REVISION 3 SUPERSEDES REVISIONS 1 & 2

MARK	DATE	DESCRIPTIONS	BY	CH'D	CCO#
4	03/25/11	HINGE A BARRIER RAIL MODIFICATIONS	TH	GB	25SI
3	10/22/10	HINGE A BARRIER RAIL MODIFICATIONS	TH	GB	25SI
2	01/30/09	HINGE A BARRIER RAIL MODIFICATIONS	TH	AB	25SI
1	03/28/08	HINGE A BARRIER RAIL MODIFICATIONS	TH	AS	25SI

SAN FRANCISCO OAKLAND BAY BRIDGE
EAST SPAN SEISMIC SAFETY PROJECT
SELF-ANCHORED SUSPENSION BRIDGE
(SUPERSTRUCTURE & TOWER)

BARRIER DETAILS NO.5

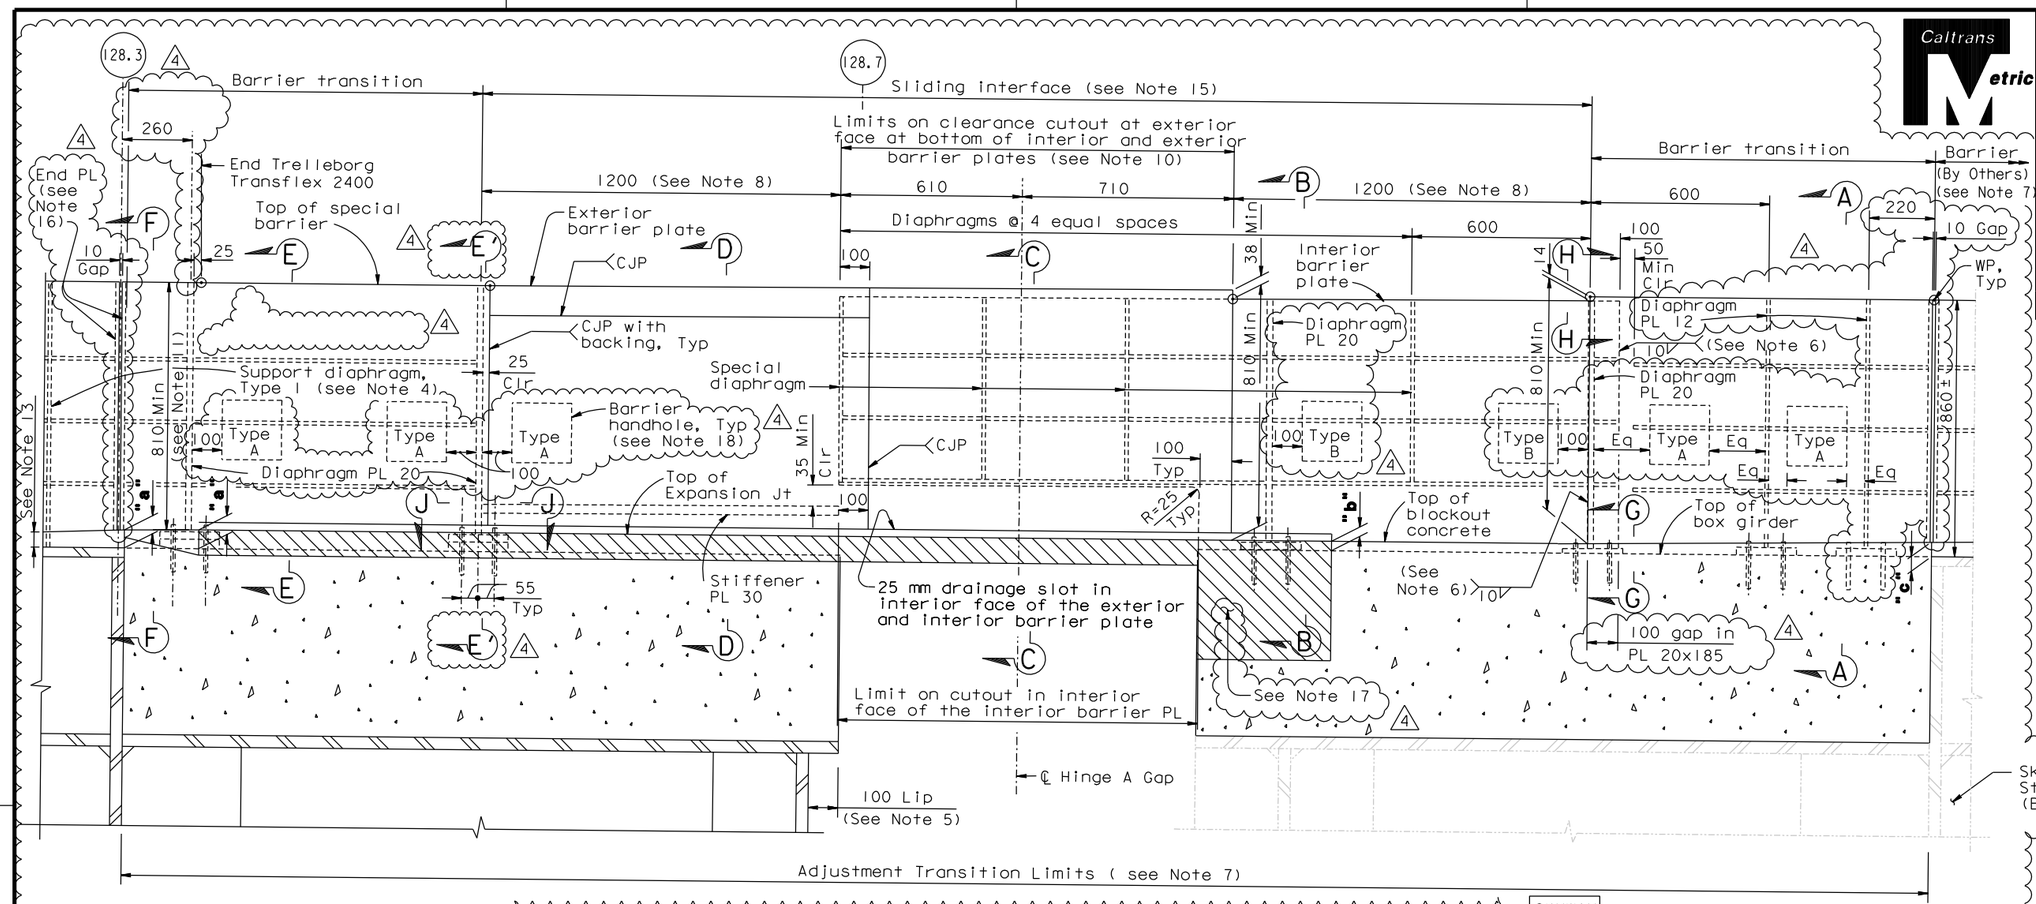
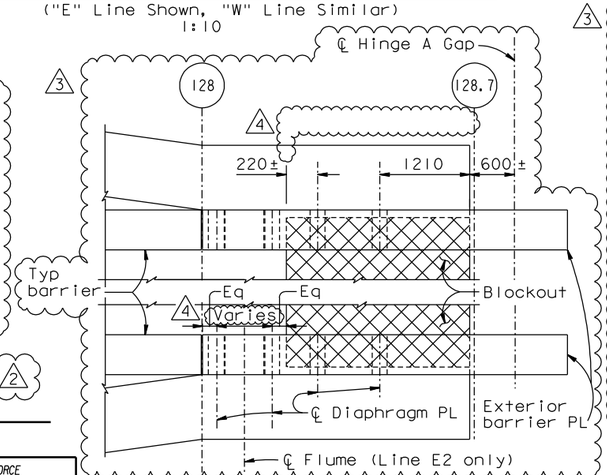
10. Cope barrier PL to clear PL 20x185, see Section C-C on "Barrier Details No.6" sheet.
11. Shim North barrier on SAS as required to match barrier height at Expansion Joint. Barrier slope shall not exceed 1%. Shim PL shall be installed under the barrier base PL and under the barrier connections. The drainage cut-out in the barrier diaphragm shall not be blocked and the caulk bead shall be thickened appropriately.

12. Unless noted otherwise where calculated overlay at shoulder is greater than 50, overlay shall be tapered to 50 at barrier outside the "Adjustment Transition Limits" to maintain 810 min above the overlay at the barrier.

13. Runoff the overlay to 50 mm thick at a rate no steeper than 1:100, in shoulders beyond expansion joint transition.
14. Expansion joint shall be laid following longitudinal profile with constant cross slope throughout the expansion joint.

15. The interior and exterior barrier plate at sliding interface shall be parallel to allow for longitudinal movement without binding.

At the Contractor's option, the barrier may be detailed straight from PP128.3 to the existing Skyway barrier, subject to review and approval of the Engineer.
